City of Alamo
Water Treatment Plant Claricone Rehabilitation and Protective Coating Phase 1B
RFB# 2025-10-25

ADDENDUM 1
November 14, 2025

CLARIFIER NO. 1 AND NO. 2 SECTION

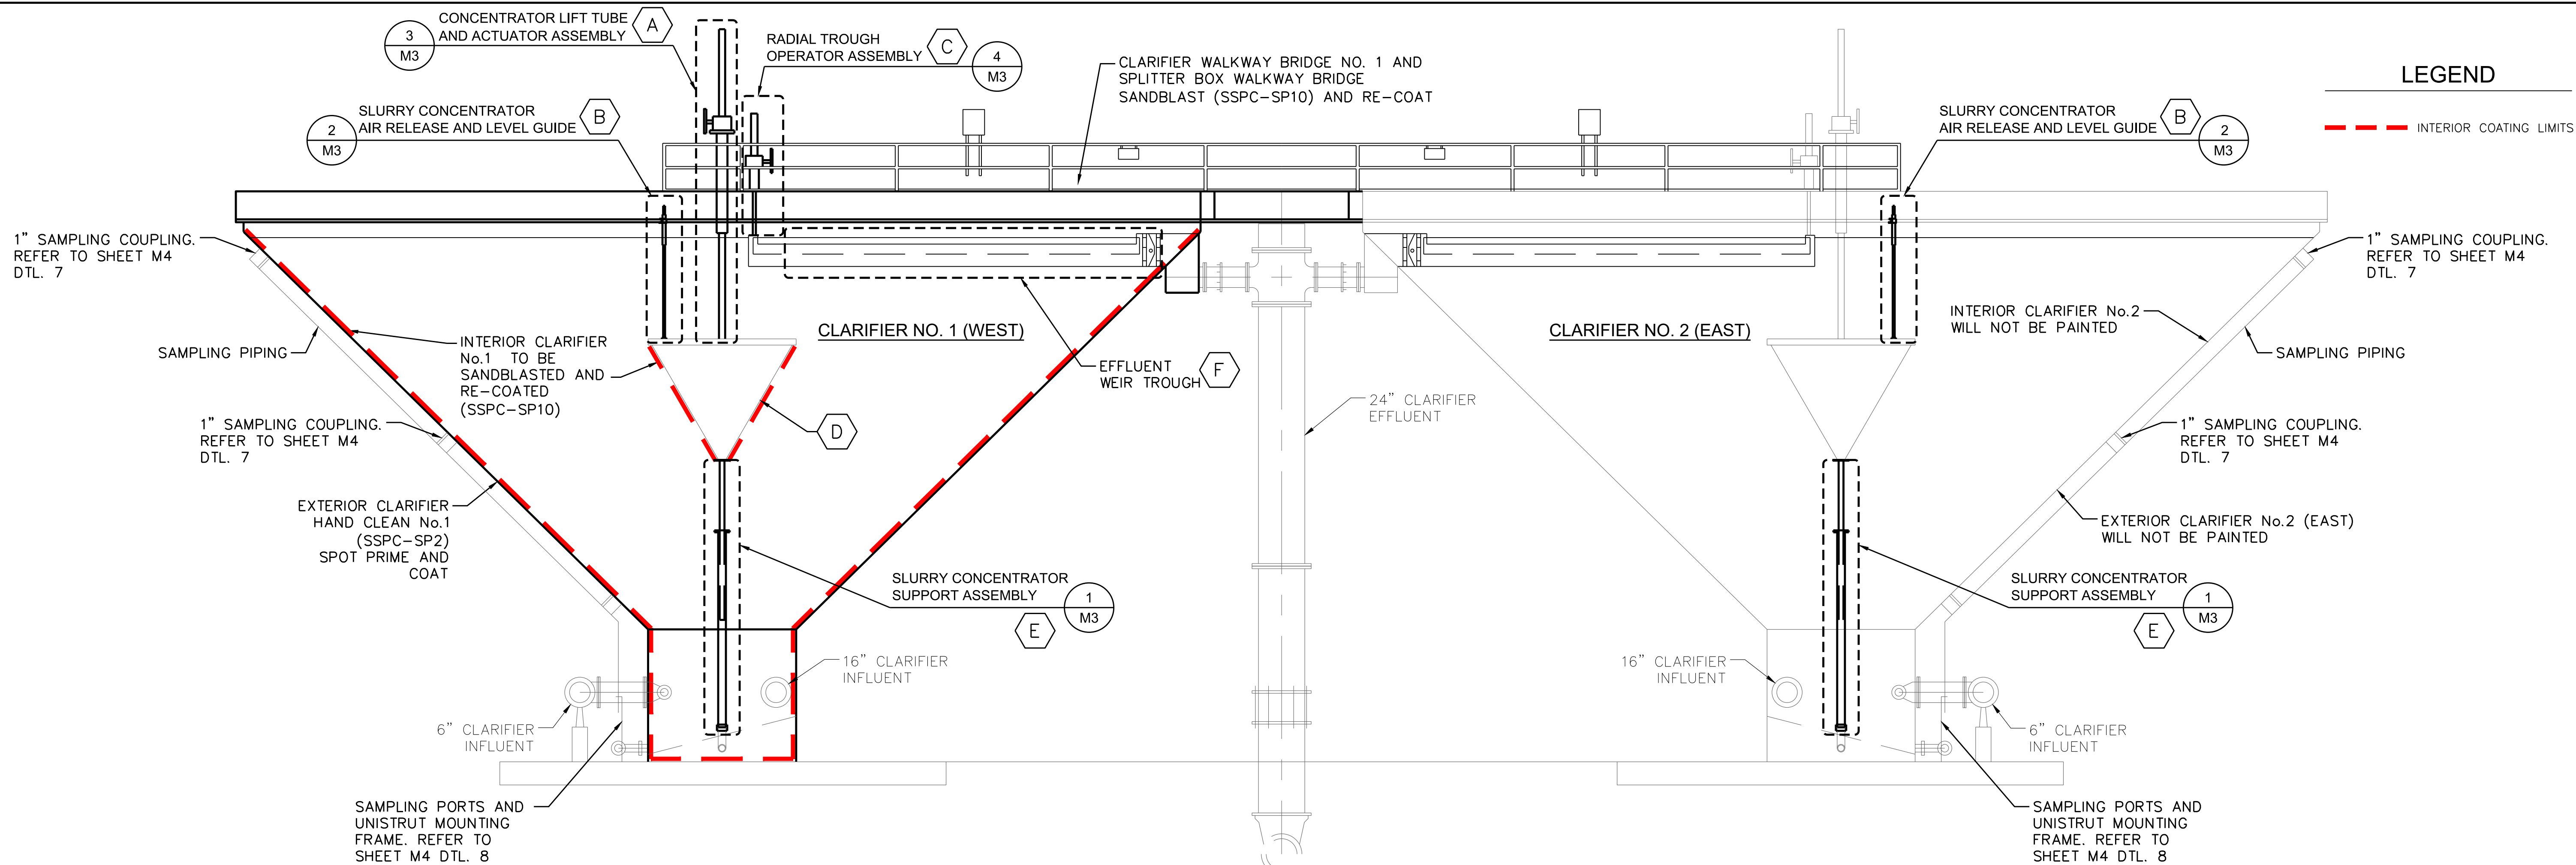
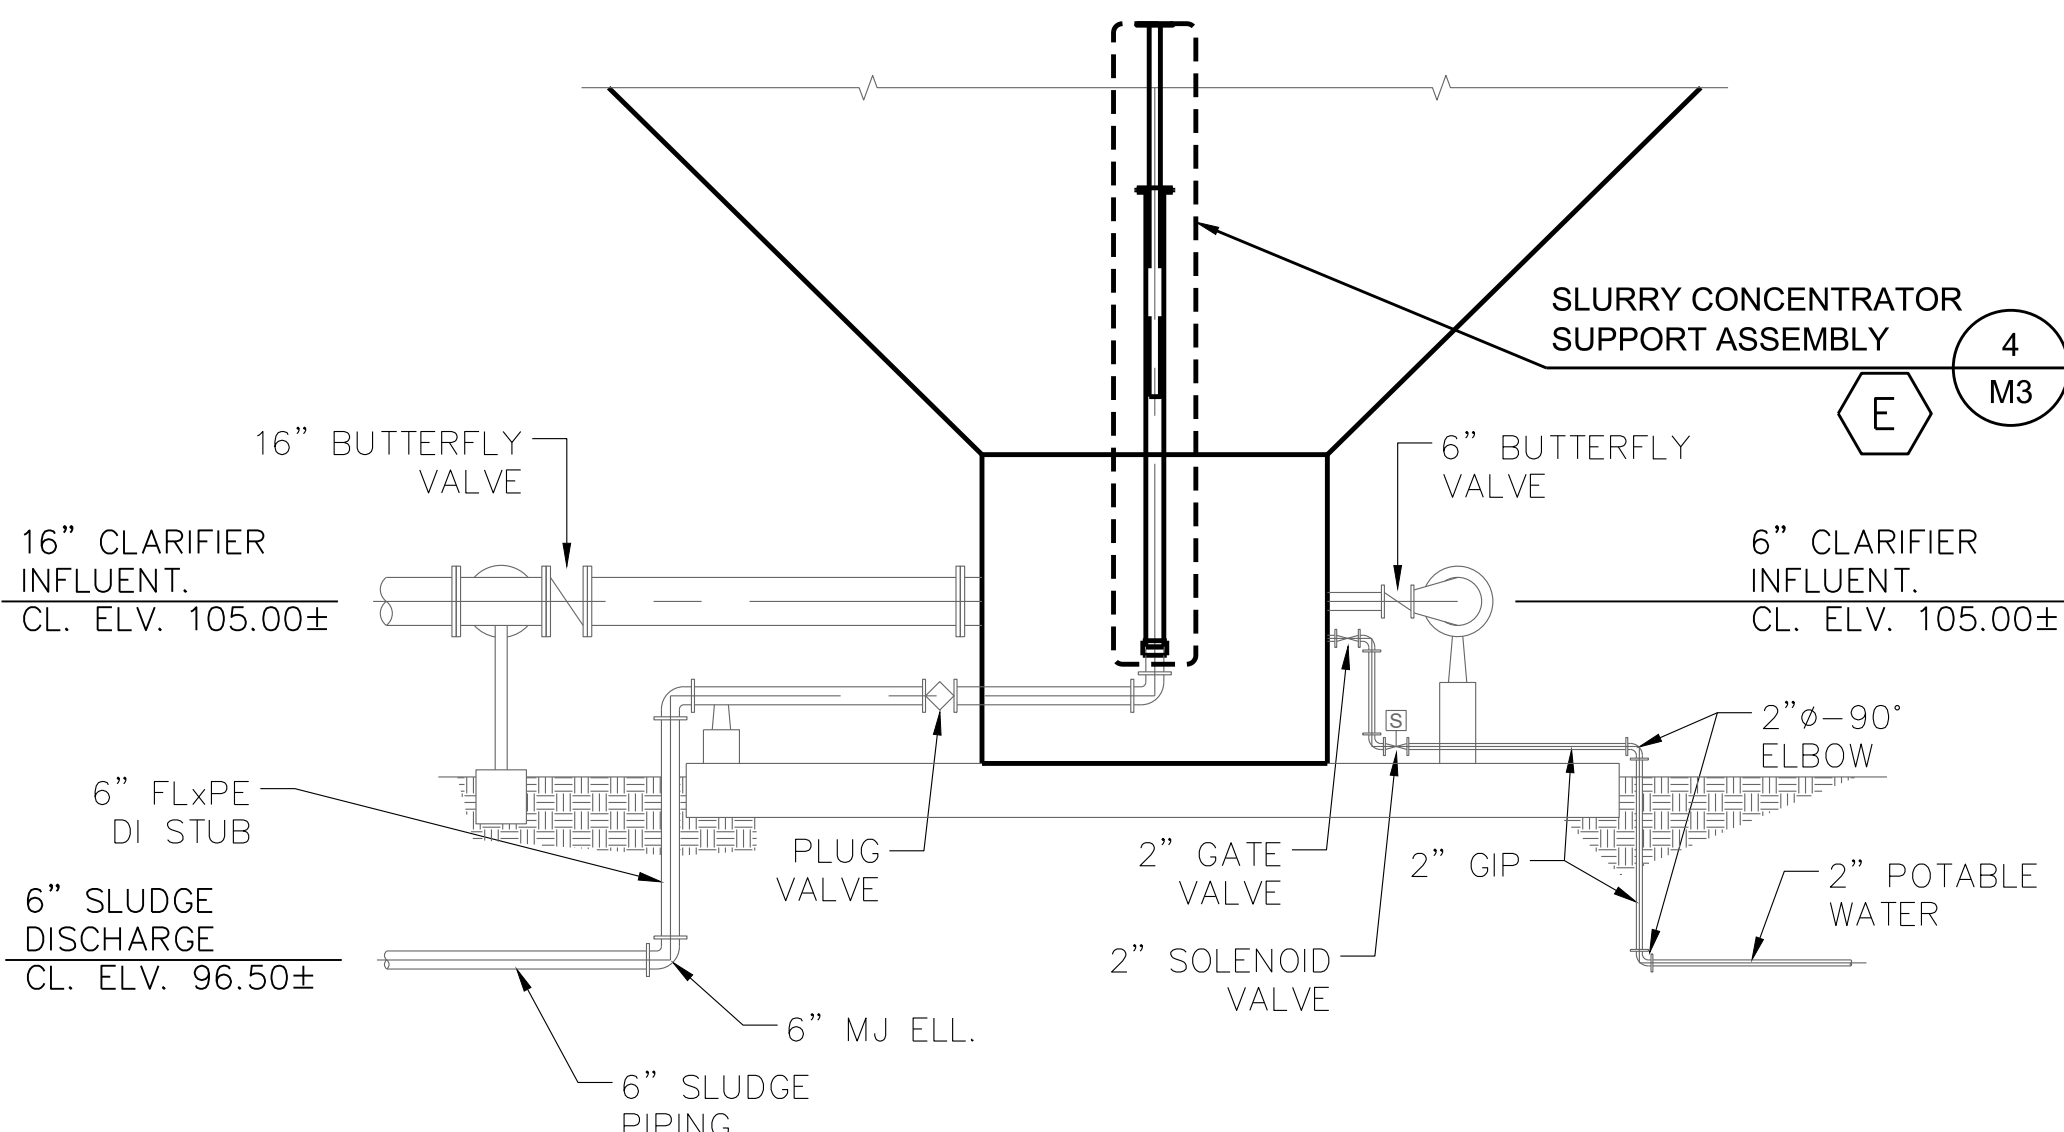
1. Any holes in Clarifier No. 1 shall be accomplished by welding a steel section/coupon. Refer to revised drawing, Sheet M2 - Clarifier No. 1 and 2 Section. A bid line item was added for this work, Refer to Bid Item No. 9.

4. Plan Sheet M2 Clarifier No. 1 and 2 Section – Remove in its entirety and replace with the version attached to this Addendum.

- REMOVE AND REPLACE SLURRY CONCENTRATOR LIFT TUBE ASSEMBLY. CLARIFIER NO. 1 ONLY.
- REMOVE AND REPLACE ROD/PIPE LEVEL GUIDE. CLARIFIER NO. 1 AND 2.
- REMOVE AND REPLACE WEIR TROUGH OPERATOR. CLARIFIER NO. 1 ONLY.
- REUSE EXISTING SLURRY CONCENTRATOR. CLARIFIER NO. 1 AND 2.
- REMOVE AND REPLACE SLURRY CONCENTRATOR SUPPORT ASSEMBLY, CLARIFIER NO. 1 AND 2.
- ENGINEER, CONTRACTOR, AND OWNER WILL INSPECT EFFLUENT WEIR TROUGH AFTER CLARIFIER IS DEWATERED AND CLEANED. AN ALLOWANCE (ALLOWANCE NO. 1) IS INCLUDED TO EITHER REPAIR OR REMOVE AND REPLACE WITH A NEW EFFLUENT WEIR TROUGH.
- PATCH ALL PIN HOLES WITHIN CLARIFIER PERIMETER USING 1/4" A36 STEEL PLATES WELDED TO CLARIFIER. QUANTITY OF REPAIRS/PIN HOLES REQUIRED IS UNKNOWN. A BID ITEM IS INCLUDED FOR THIS WORK.

PATCHALL PIN HOLES WITH 1/4" STEEL PLATE (WELDED) OVERLAP 2"
